Subject ▶ Changes on spindle and drill chuck.

For Models ▶ HP1500, HP1200, HP1210, HP1501, HP1510

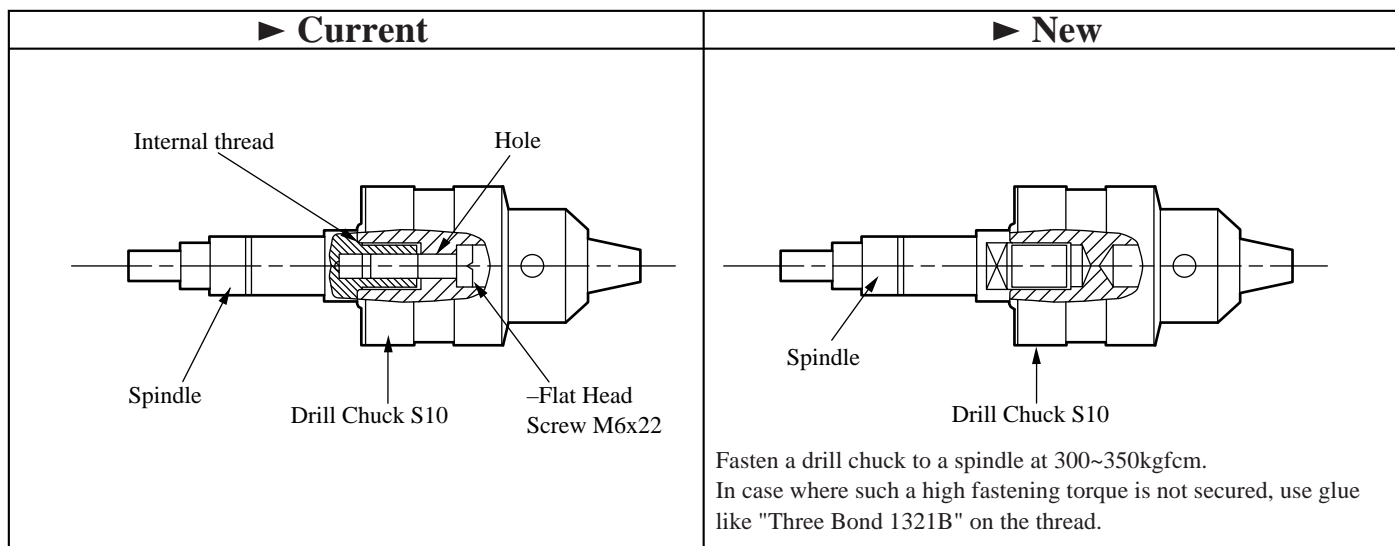
Description ▶ — Flat Head Screw M6x22 (251460-1), used for fastening Drill Chuck to Spindle, has been discontinued. With this Change, both spindle and drill chuck have been changed as shown below.

Interchangeability mark: <= means the new part can be substituted for the current.

=> means that the current can be substituted for the new.

*1. HP1210 and HP1510 don't use a — Flat Head Screw on current type.
